Zoning & Subdivision Committee
Thursday, February 14, 2013 12:15 pm

JEROME VILLAGE GLACIER PARK NEIGHBORHOOD SECTION 2 PRELIMINARY PLAT

REQUEST: Approval of the Jerome Village Glacier Park Neighborhood Section 2 Preliminary Plat in Jerome Township, Union County

SHEET NO.: 9/29

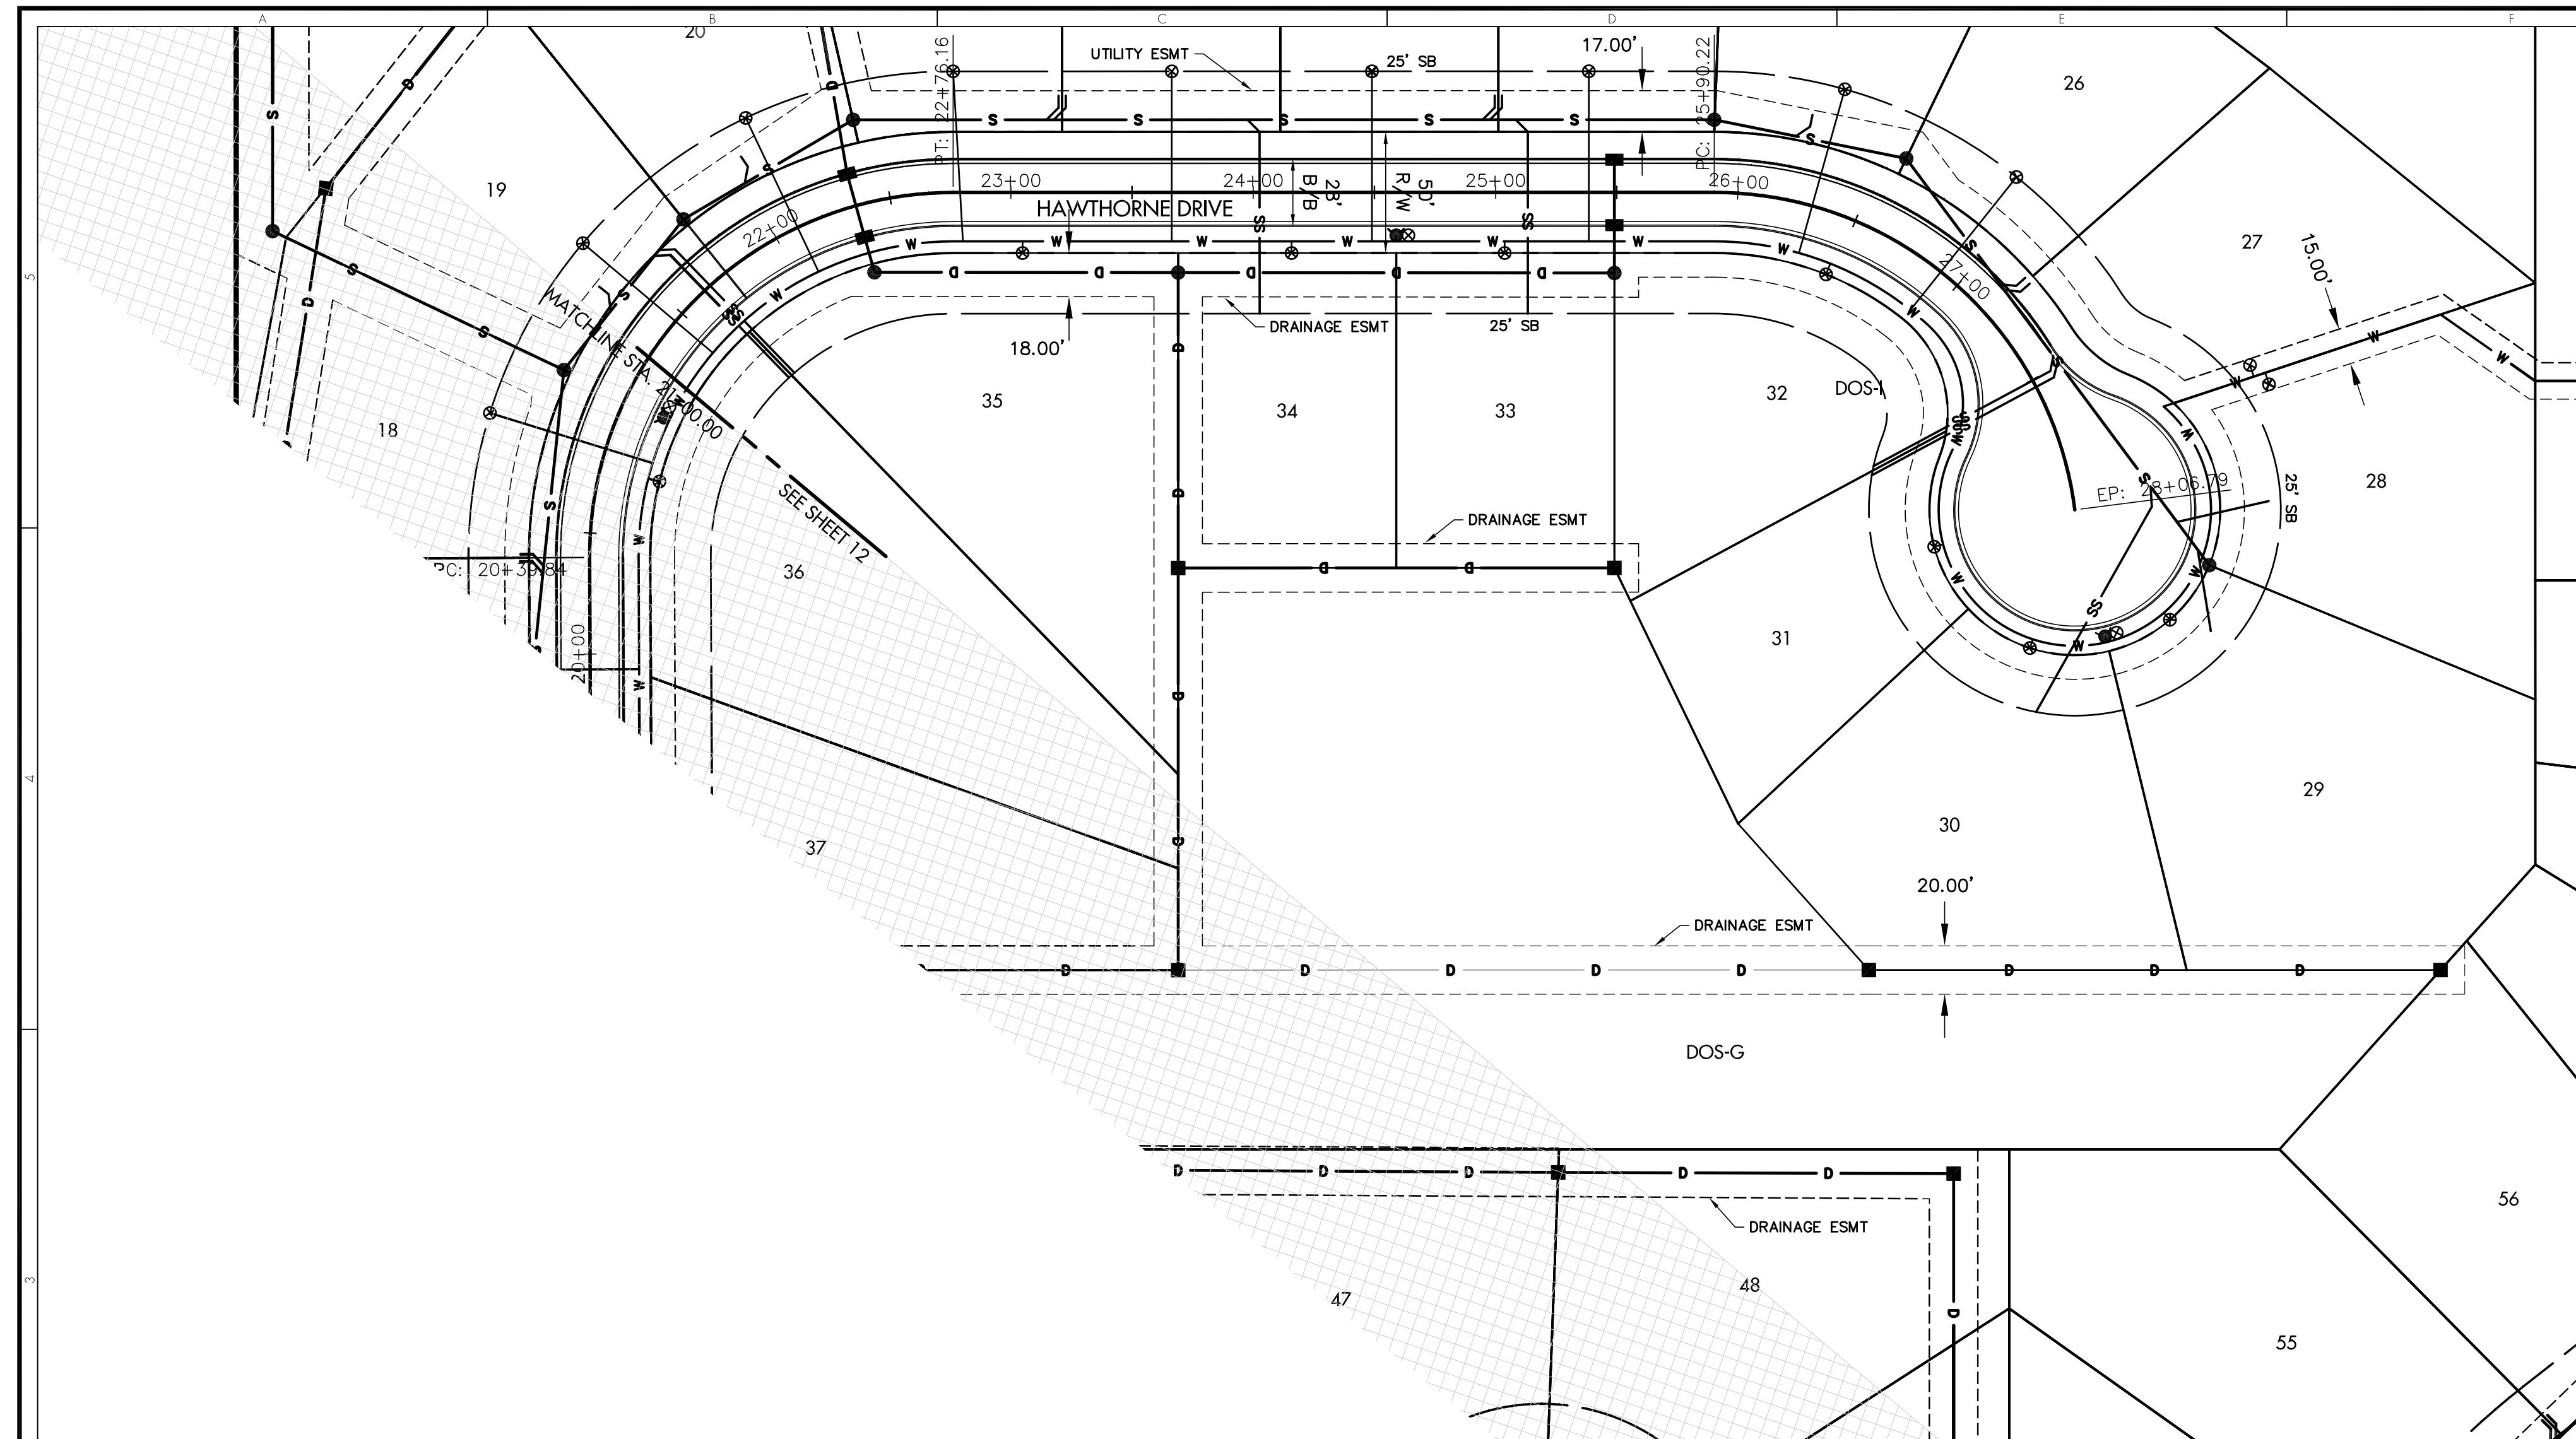
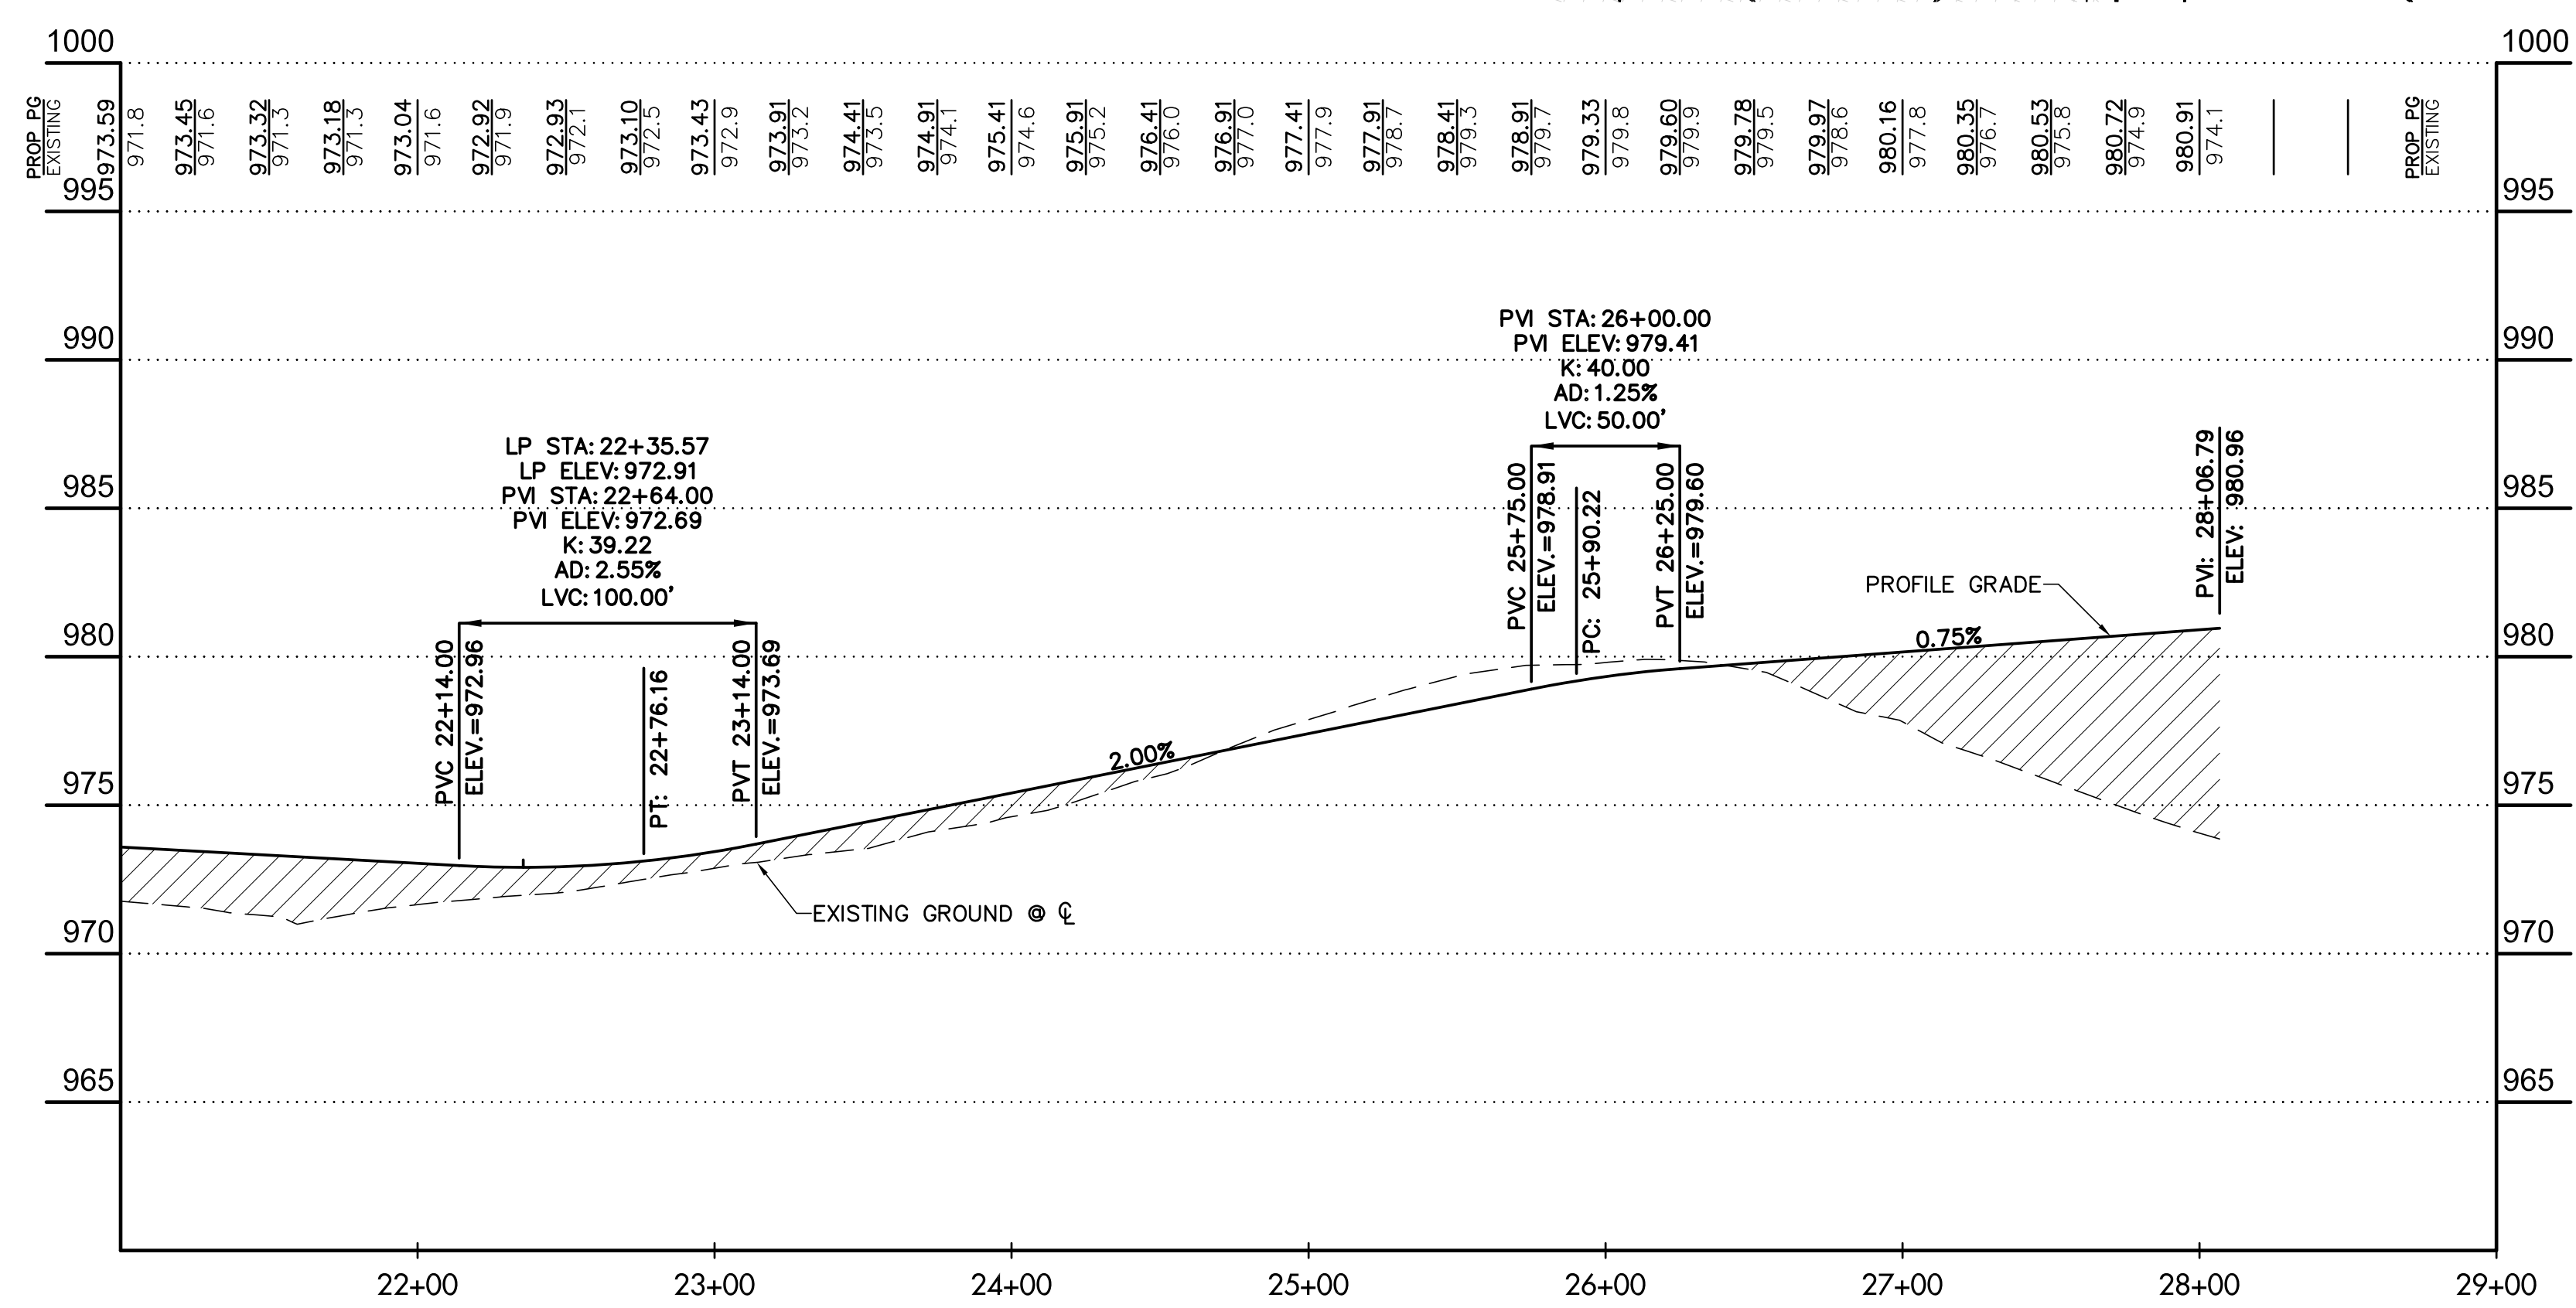
Detailed Composite Utility Plan (Sheet 9):

1. For isolation purposes, please add a valve just east of the Cottonwood Drive cul-de-sac. This valve should also be located east of the proposed service for the adjacent lot.
2. For access (and constructability) purposes, please add a sanitary manhole just west of Jerome Road.
